ADDENDUM NO. 1

PROJECT NAME: Life Sciences Annex – North and East Wing Renovations
UNL PROJECT NUMBER: A090P025 & A090P026

DATE OF ISSUANCE: February 6, 2012
DATE OF BID OPENING: Tuesday February 14, 2012 @ 2:00 p.m. CDT

5 EAST ELEVATION AREA 'A' & 'B'
SCALE: 1/8" = 1'-0"

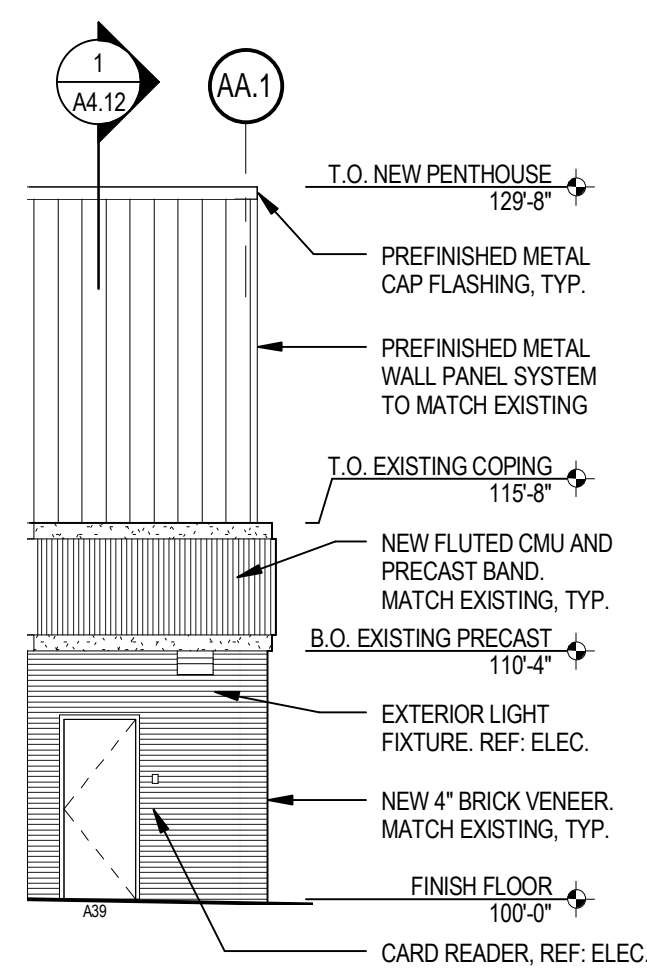
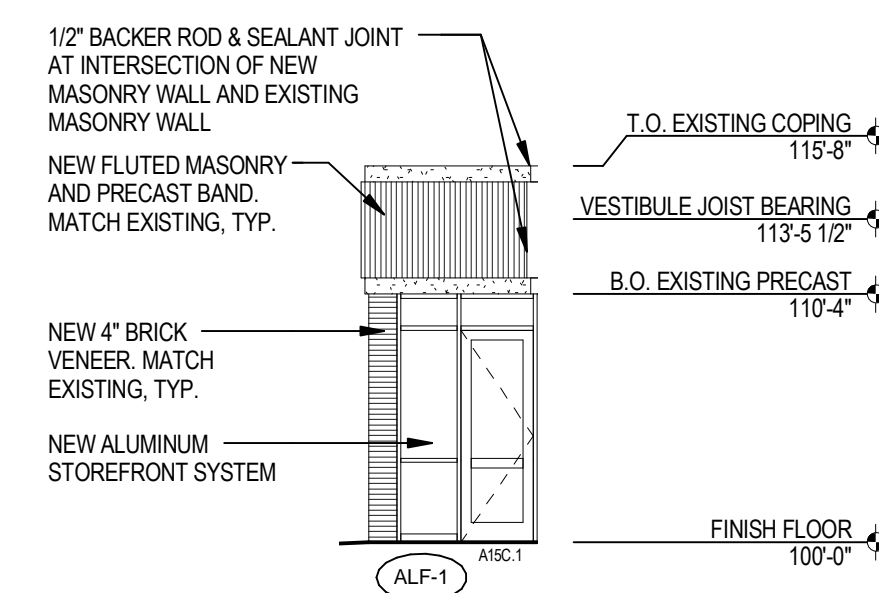
Sheet A2.11 has been updated. See attached reissued sheet with changes indicated.
